SERVICE BULLETIN: JSB 004-4

Issue: 4

Subject: Jabiru Engine Oil Pump / Cooler

Affected Models: Jabiru 2200 and 3300 engines

Figure 1. Front Side of Port Plates (Tractor Installation)

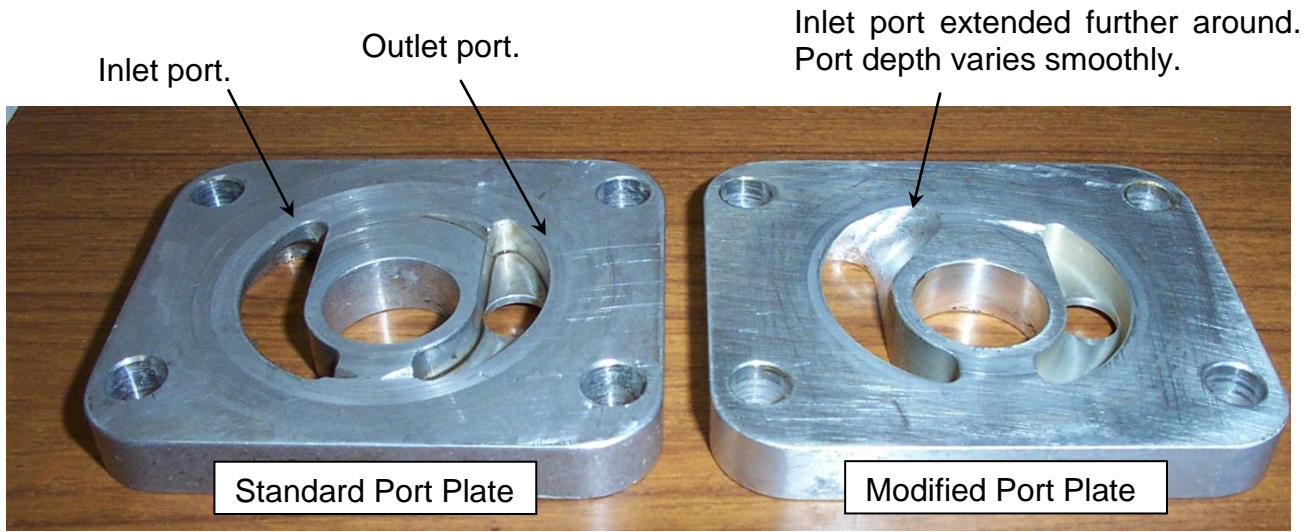
The oil pump port plate can be reworked to reduce cavitation. Refer to Figures below. This change supersedes the port plate modification detailed in **Issue 3** of this Bulletin.

- e) Place the port plate back on the engine. Ensure that the plate is oriented correctly, as shown in Figure 1. The inlet port is on the Passenger's side of the aircraft (tractor installation). The less symmetric face of the port plate (the side with one large, curved port and one smaller, round port) mates to the crankcase.

Figure 3. Port Plate Evolution

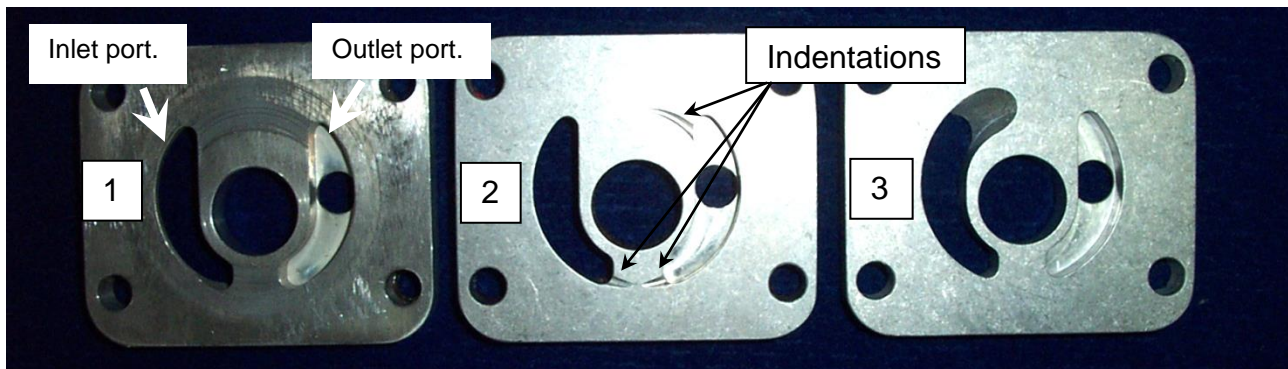
The Figure above shows 3 different styles of oil pump port plate.

Plate #1: This is the original design, with the port plate outline unbroken by indentations.

Plate #2: This is a more recent design. At the top of the outlet port and at the bottom of both ports there are small tapered indentations. Some versions of this plate will only have the larger indentation at the top of the outlet port, and not the pair at the bottom.

Plate #3: This is the current plate design. The small indentations have been replaced by a large tapered cut at the top of the inlet port. Changes have also been made to the other side of the plate (which faces the crank cases) to remove sharp edges & reduce cavitation.

Plates like Plate #1 & Plate #2 can be modified to be equivalent to Plate #3. Where the plate already has the indentation on the top of the outlet port, care must be taken to leave at least 2mm between it and the end of the new cut on the inlet side.

Figure 4. Modified Port Details

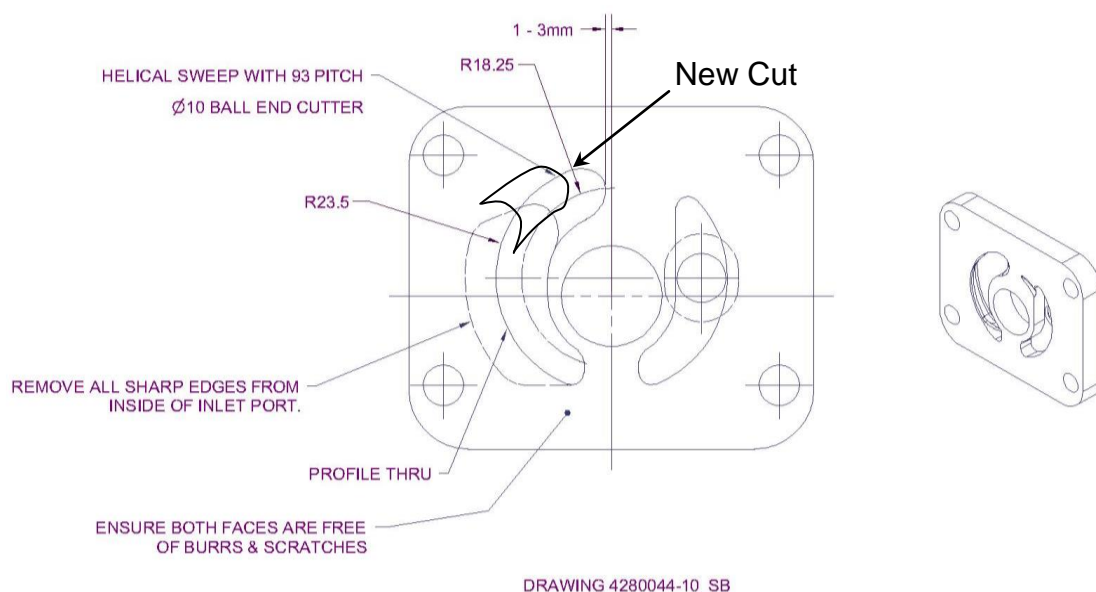
This work can be carried out by hand using a Die Grinder or similar tool. Jabiru Aircraft can provide a 1:1 template if required. This work requires the disassembly of the oil pump and should only be carried out by an approved person with appropriate skills.
